ADA COMPLIANCE PROGRAM

Clark County Facilities Transition Plan Public Service Center Parking Garage and Accessible Routes

Date of Survey: March 27, 2006
 Conducted by: Clark County Citizen ADA Advisory Board

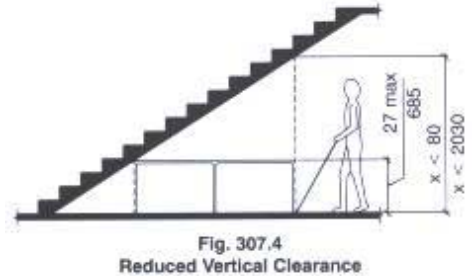
Pedestrian crosswalk into a traffic way. No truncated domes.

See truncated domes above.

Truncated domes needed on crosswalks between Public Service Center and Courthouse on 13th Street.

<p>Item: Detectable Warnings</p> <p>IBC- Section 1102 Definitions – Detectable Warnings – A standardized surface feature built in or applied to walking surfaces or other elements to warn visually impaired persons of hazards on a circulation path.</p> <p>ANSI Code: 705.2 Standardization – Detectable warning surfaces shall be standard within a building, facility, site or complex of buildings</p>
 	<p>ANSI 705.5 Truncated Domes – Detectable warning surfaces shall have truncated domes complying with Section 705.5</p> <div data-bbox="597 1157 1393 1535">  <p style="text-align: center;">(a) Plan</p> <p style="text-align: center;">(b) Elevation (Enlarged)</p> </div> <p style="text-align: center;">Fig. 705.5 Truncated Dome Size and Spacing</p>
	<p>A thorough review of all walking surfaces, crosswalks, and driveway entrances should be conducted to determine the number and locations of required truncated domes.</p> <p>The standardized color, to maintain a consistent theme per ANSI Code 705.2 should be safety yellow.</p>
